FINDINGS AND RECOMMENDATION OFFICE OF PLANNING AND ZONING ANNE ARUNDEL COUNTY, MARYLAND

COUNCILMANIC DISTRICT: 7 CASE NUMBER: 2025-0038-V

The applicant is requesting a variance to allow a dwelling with less setbacks than required and with greater coverage by structure than allowed on property known as 4812 Avery Road in Shady Side.

4812 AVERY ROAD VARIANCE PLAN

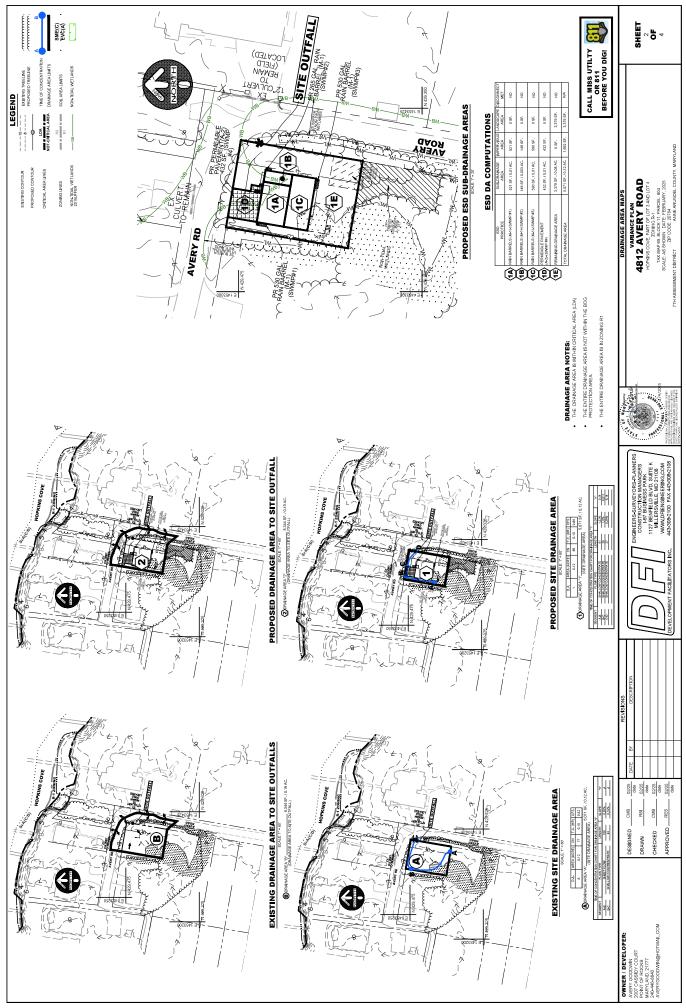
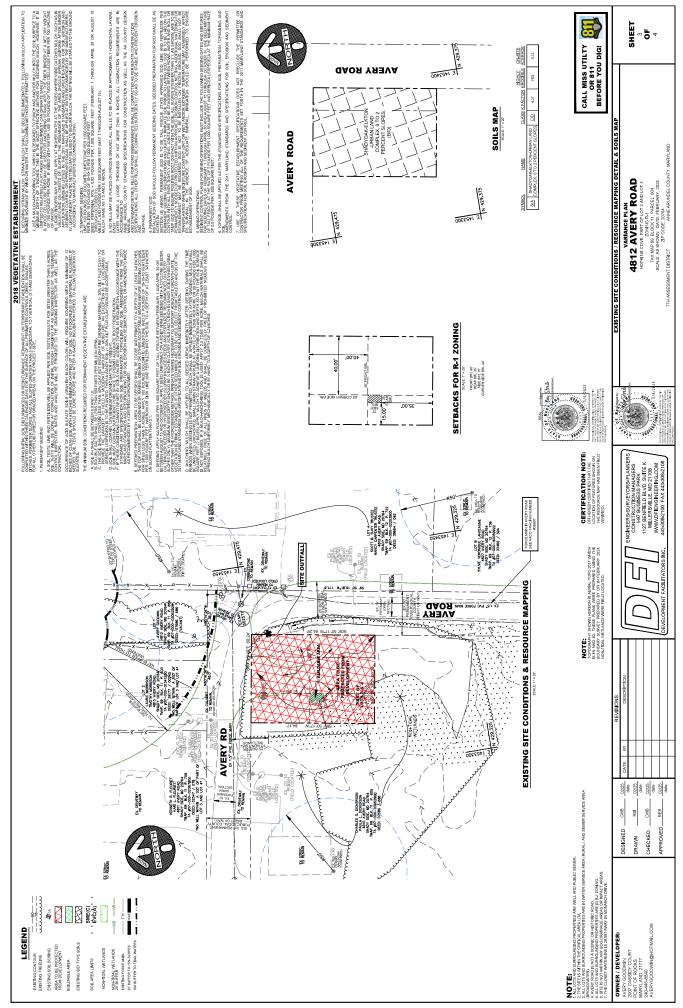
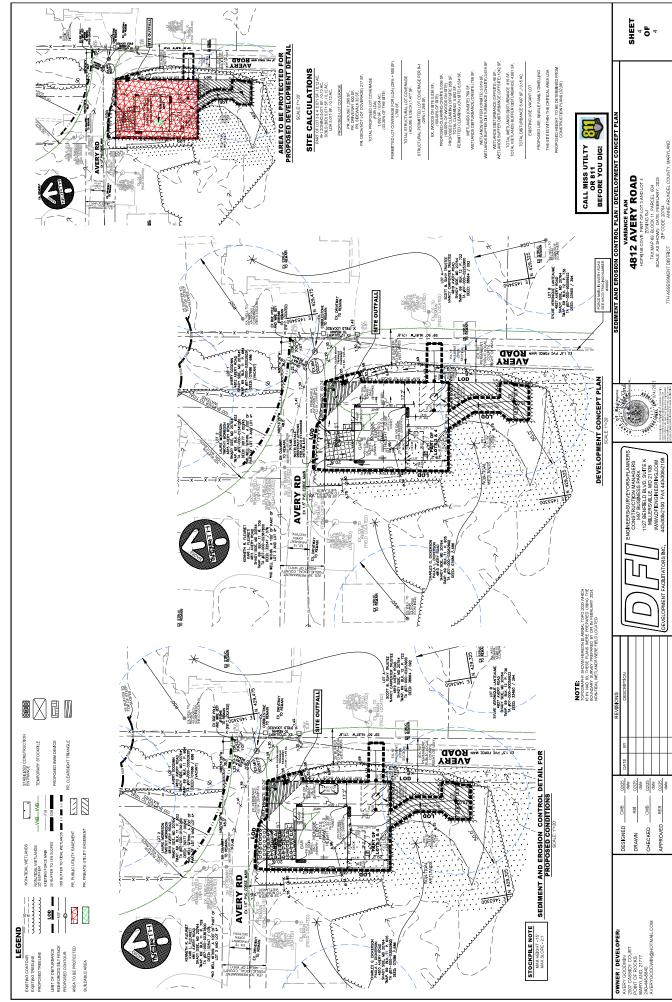
The **Health Department** commented that based on the site plan submitted under G02020267, the proposed well location cannot be approved as shown and the Department recommends denial of the variance at this time.

- 1. A double driveway and deck are proposed, though not necessary. The double driveway and deck provide unnecessary additional lot coverage. We defer to the Office of Planning and Zoning.

- 2. Per the drainage arrows and existing and proposed topography on the Variance Plan, a low point is present and will puddle at the northeastern corner at low spot elevation of 6.52. It does not appear storm drain pipes are present to drain the water. Water cannot puddle or flood onto a public road.

- 3. The existing Avery Road crosses on the existing lot. The road falls within the proposed clear sight triangle. The clear sight triangle does not allow or permit a public road onto private property. An access easement or right-of-way dedication may be required. Refer to the Department of Public Works (DPW) for additional information.

- 4. Add a note to the Grading Plans that the rain barrels are to be emptied between rain events.
- 5. Per DPW's Design Manual, Chapter III Roads and Streets (p. 26), "No driveway shall be located within 50 feet from the P.C. [Point of Curve] of the intersection curb radius."

- 6. Per MDE's Stormwater Design Manual Volume I (p. 5.47), "The slope of the permeable pavement shall be no greater than 5%." Sheet 5 of the Grading Plan shows the slope of the permeable driveway between 6.0% and 7.16%.
- 7. Per MDE's Stormwater Design Manual Volume I (p. 5.50), "Permeable pavements shall... be setback at least 10 feet from buildings." The permeable driveway extends to the garage.
- 8. Comments # 2 7 can be addressed at Grading Permit.
